## BULLETIN NO. 2

### 491/20167.SDW - PHASE 500: CENTER FOR FORENSIC PSYCHIATRY- CREATE KITCHEN SALINE, MICHIGAN

WTA Project No. 2021094  
MAY 14, 2025

OBJECT NUMBER <b>2021094</b>	SHEET NUMBER <b>A2.21</b>
OBJECT DATE <b>SEPTEMBER 6, 2023</b>	
CHECKED BY <b>C D S</b>

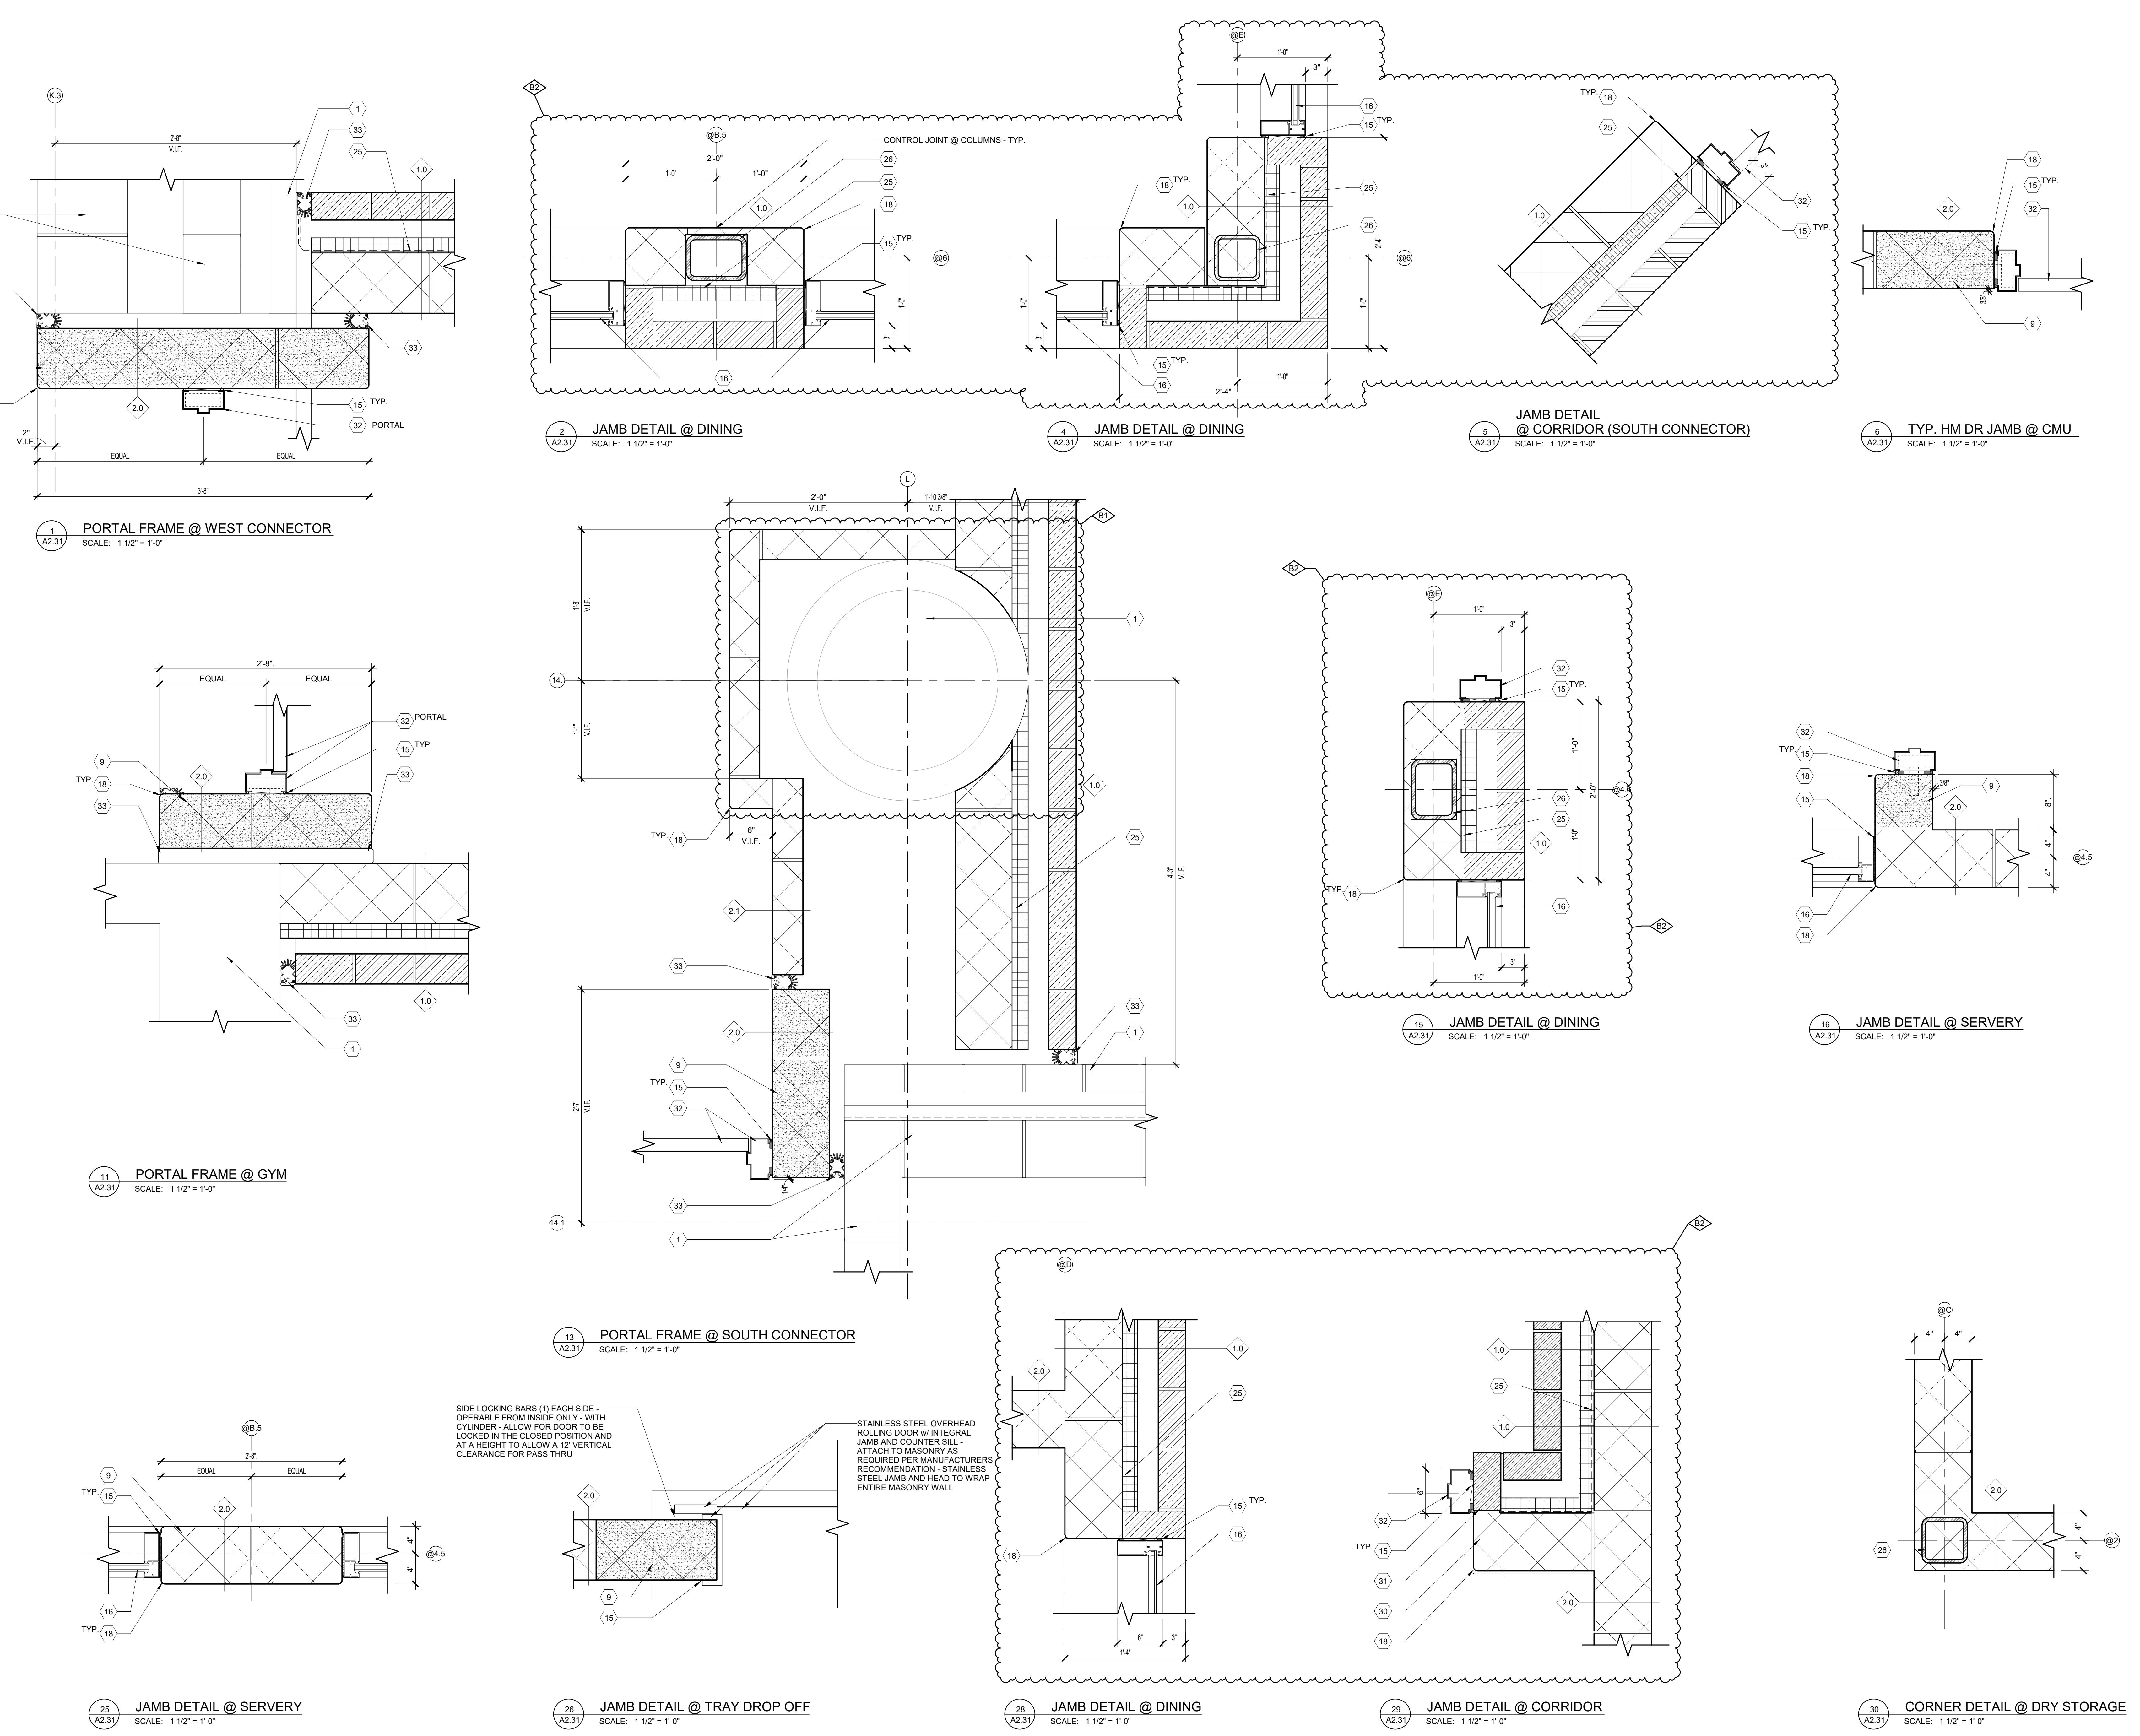
Item A1      Reference Sheets A2.21 & A3.01 (**Re-Issued**)  
A. Revised frame type F3 for doors H132.C and H131.C to have a 10" center mullein as required for detention door hardware.

CHECKED BY  
JAG  
SHEET NUMBER  
S2.01

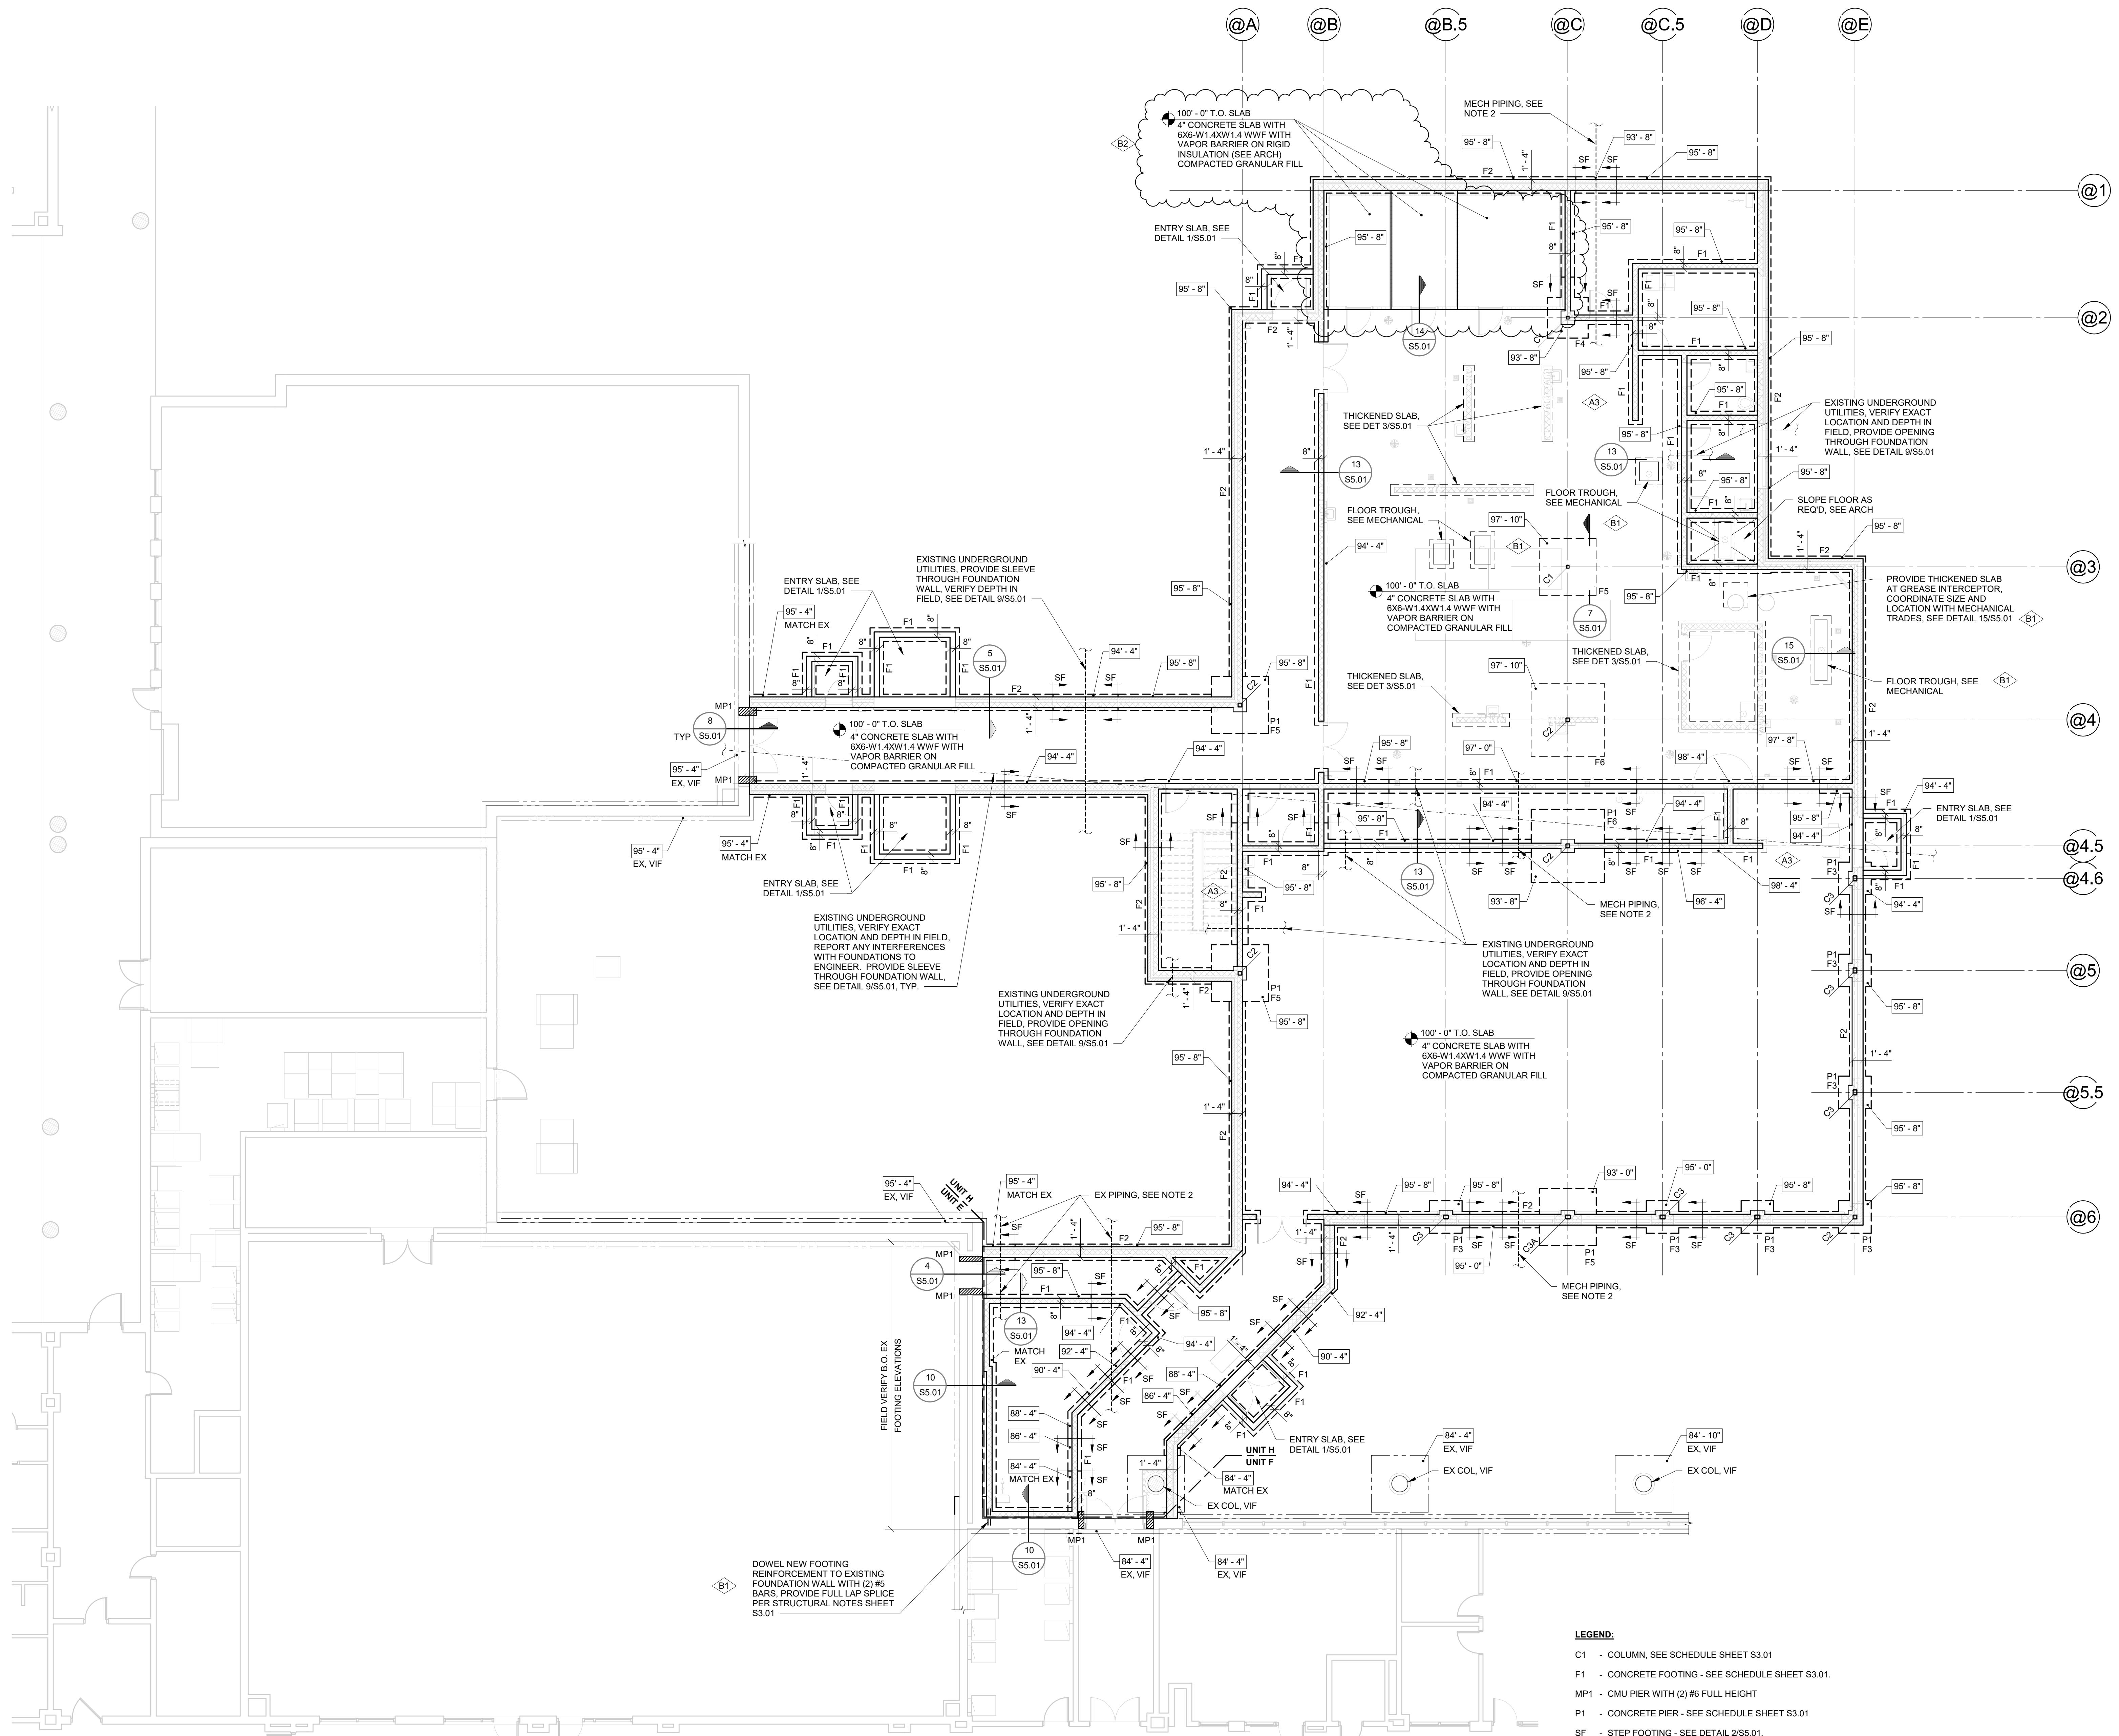
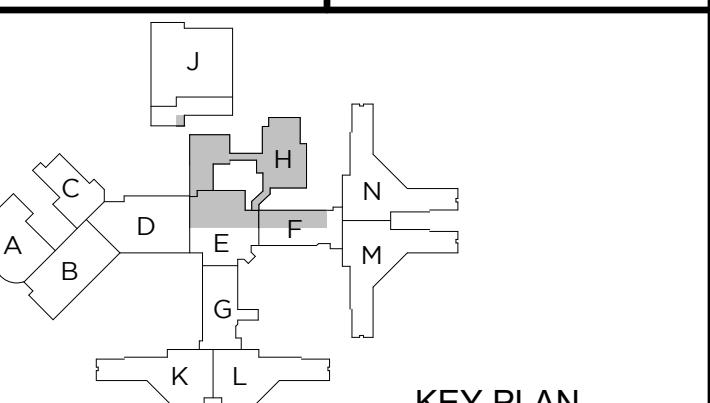
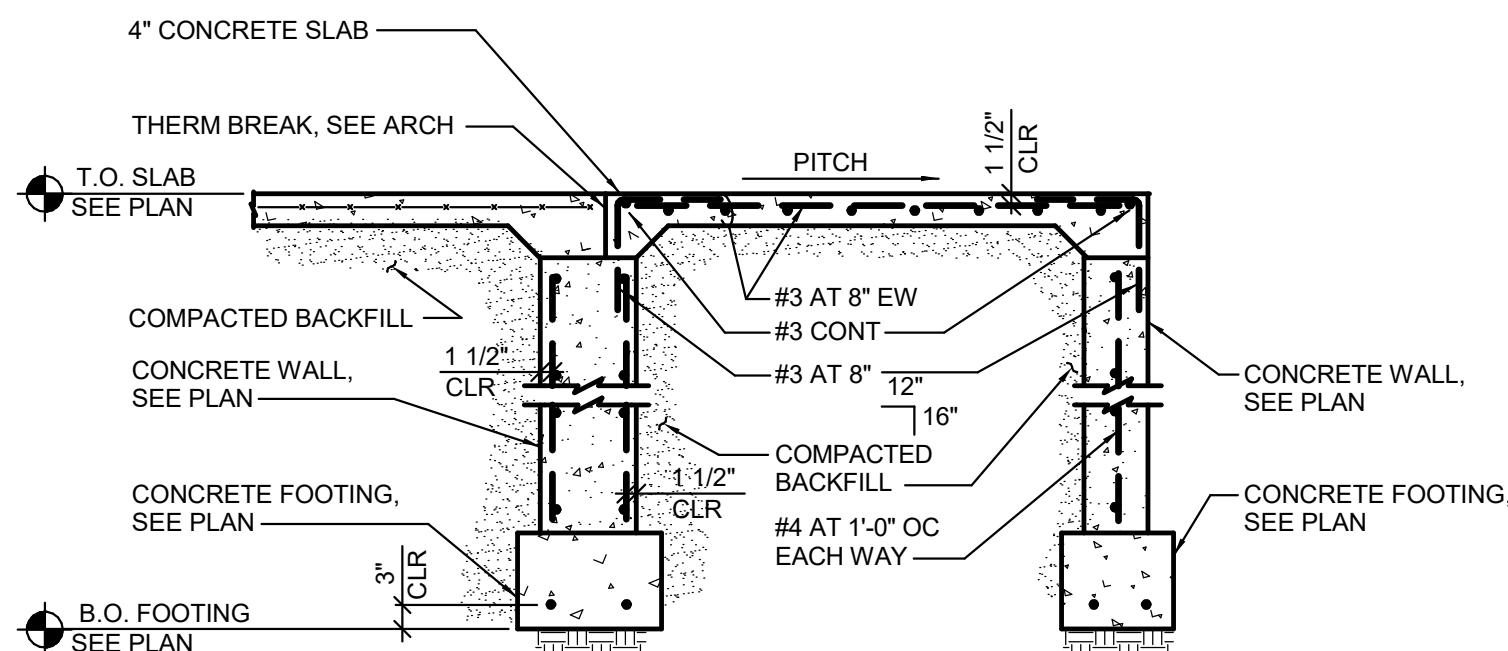
Item S1      Reference Sheets S2.01 & S5.01 (**Re-Issued**)  
A. Updated slab callouts and detail 14/S5.01 to match finalized freezer and cooler designs.
